### PRO-Z SERIES (PRO-Z 100 Series)

#### **ATTENTION: MANDATORY ACTION REQUIRED**

**Subject:** Possible Kinked Oil Lines On The Remote Oil Filter

**FIGURE 1**

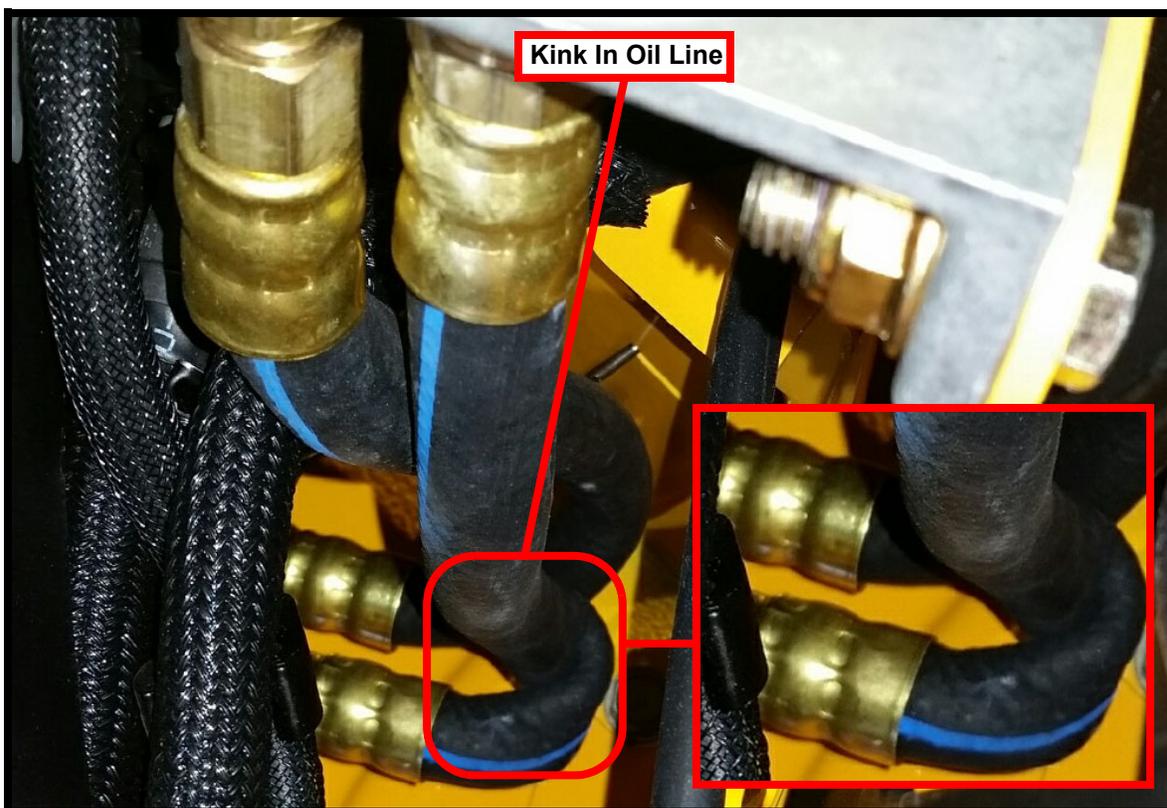
We have received reports of the oil lines possibly being kinked. This can cause the engine to be compromised of sufficient oil lubrication. Figure 1 shows one of the remote oil lines kinked.

1. Please inspect all PRO-Z 100 Models listed above in your dealer inventory. Follow the procedures listed on page 2 of this Advisory for inspecting the remote oil lines and removing the kink if needed.
